**0015** Technical Service Information**Subject:** Cylinder head gaskets**Relates to:** 61-36225-00 / -10**Make:** Opel**Model(s):** Agila, Astra, Combo, Corsa, Meriva, Tigra**Engine code:** Z 12 XE, Z 12 XEP, Z 14 XEL, Z 14 XEP**Repair thickness CHG 1.2 / 1.4
Opel Ecotec / Twinport /
Z 12 XE / P Z 14 XEL / Z 14 XEP**

Figure_Cylinder head gasket, Reinz no. 61-36225

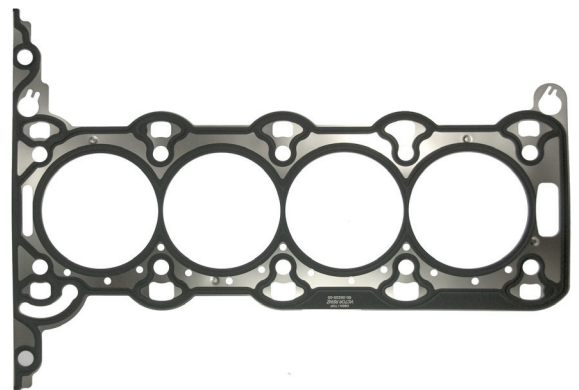
With the new exclusive repair thickness for the Cylinder Head Gasket 61-36225-00 = Opel 56 07 837, Dana offers the perfect solution for reliable sealing of reworked cylinder heads and cylinder blocks.

The repair thickness is 0.25 mm thicker than the original. After necessary surface machining, this thickness thus offers best sealing results up to this measurement.

The order number for the repair thickness is **61-36225-10**.

Caution: After the cylinder head and cylinder block have been machined, the surface roughnesses must be in a tolerance band between 7 µm and 20 µm. The waviness value should not exceed 20 µm.
